INLAND FISHERIES AND WILDLIFE NATURE PARK - ADDENDUM #1

date: May 13, 2024
project: Inland Fisheries and Wildlife Store and Admin Office Project # 3096
prepared by: Ryan Kanteres Simons Architects
Adam Wiles-Rosell Simons Architects
Mikayla Molta Simons Architects

Subject: **Addendum #1** to Bid Documents of April 23, 2024

⑥ 3D View 5

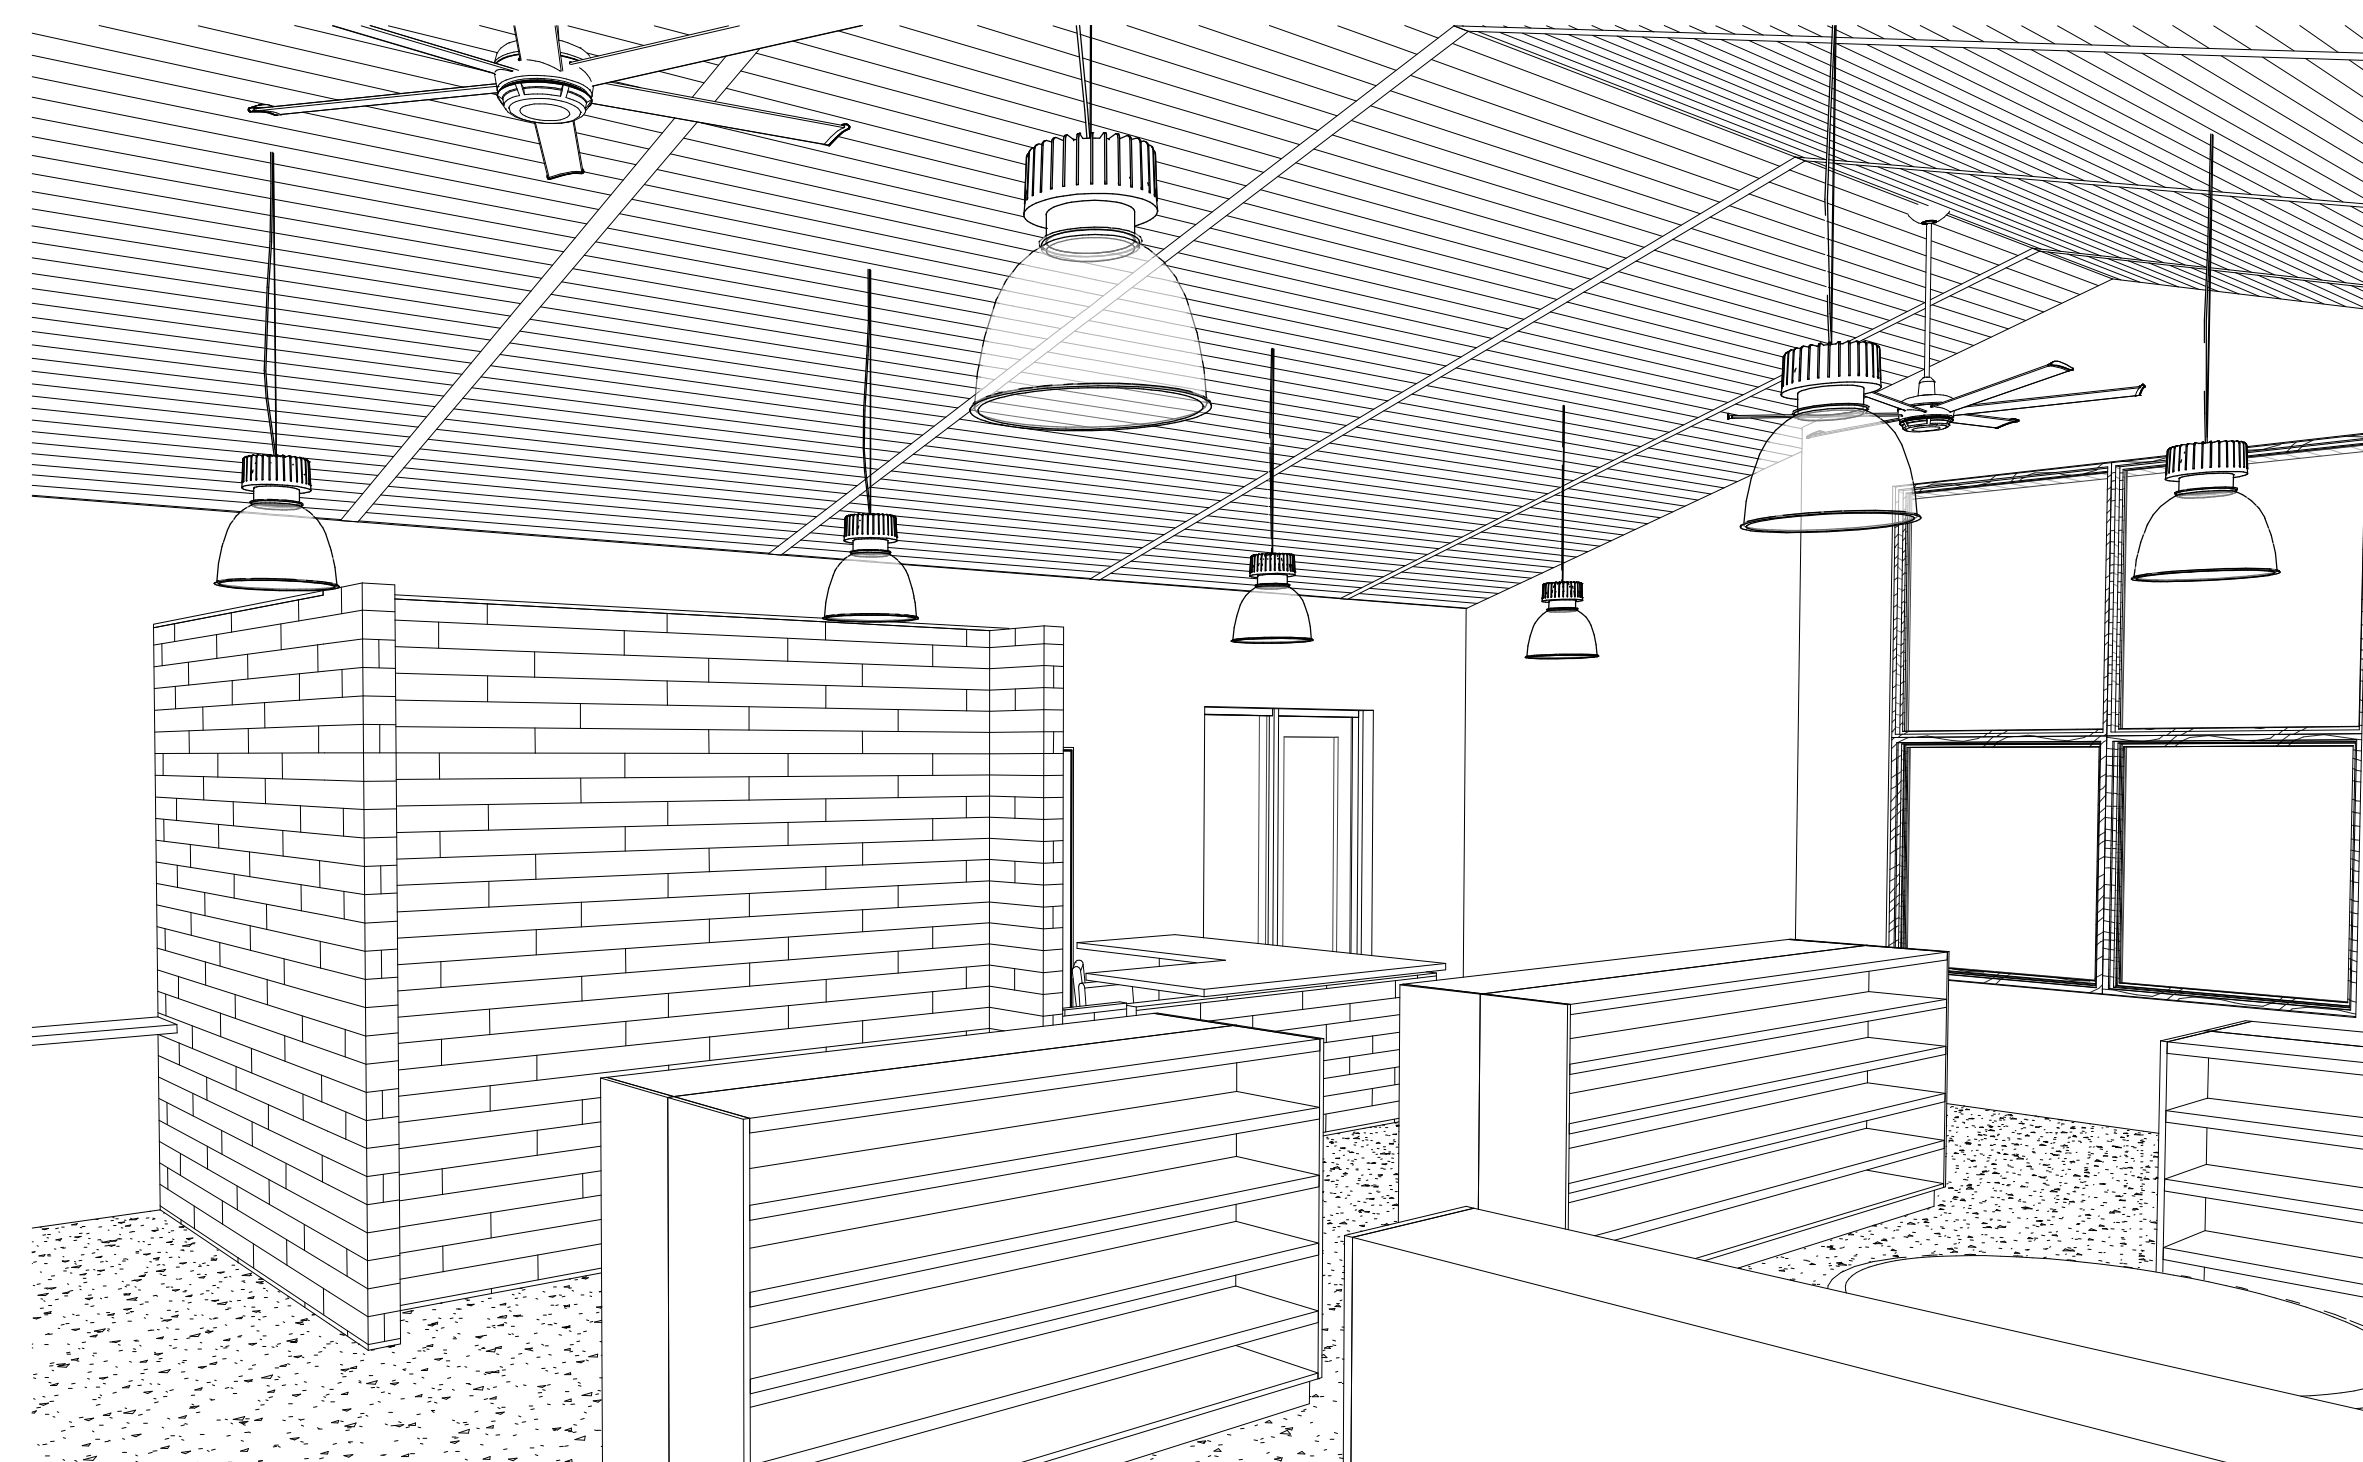
- 1-D10 Sheet A140 Located recessed fire extinguisher cabinet.
- 1-D11 Sheet A142 Coordinated interior elevations with plumbing schedule to show floor-mounted water closet fixture. Elevation 15 + 16 updated to capture Data Closet venting needs. Millwork elevation updated, see millwork details.

A201

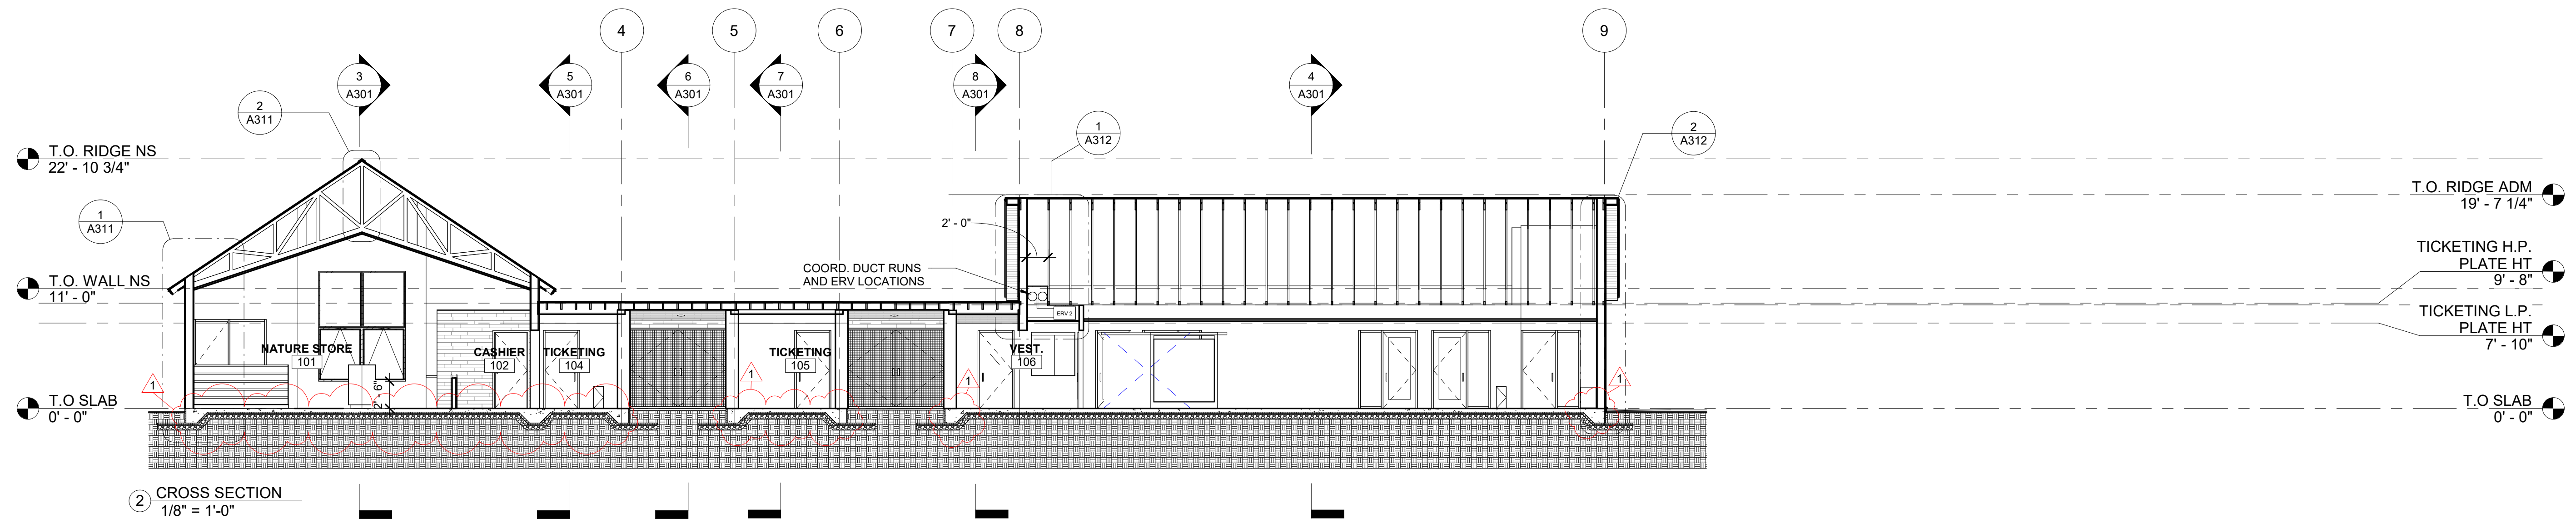
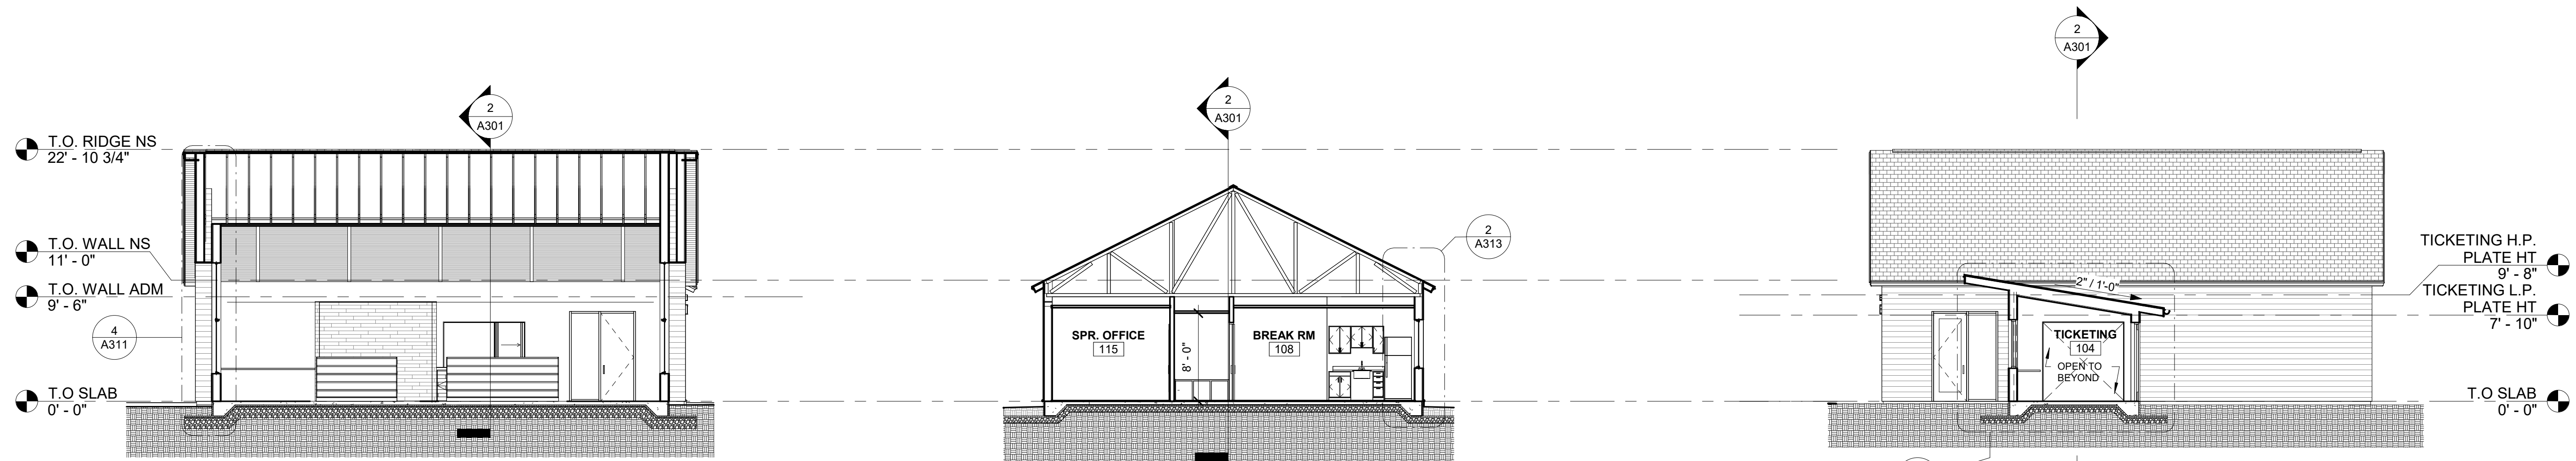
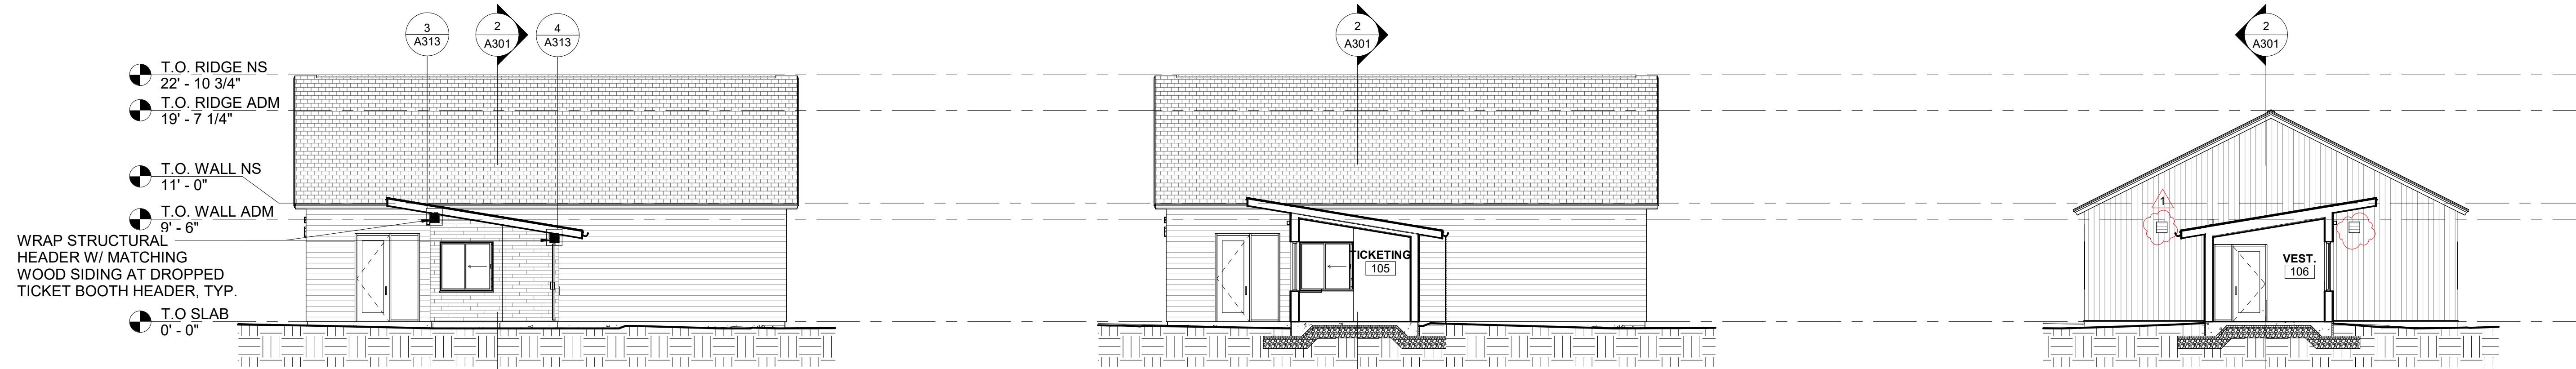
- 1-D12 Sheet A201 Tagged previously drawn exterior lighting, coordinated hose bib locations, coordinated recessed key box, and called out trimmed out exterior headers/mechanical chase at the ticketing booths. Coordinated mechanical louver locations.
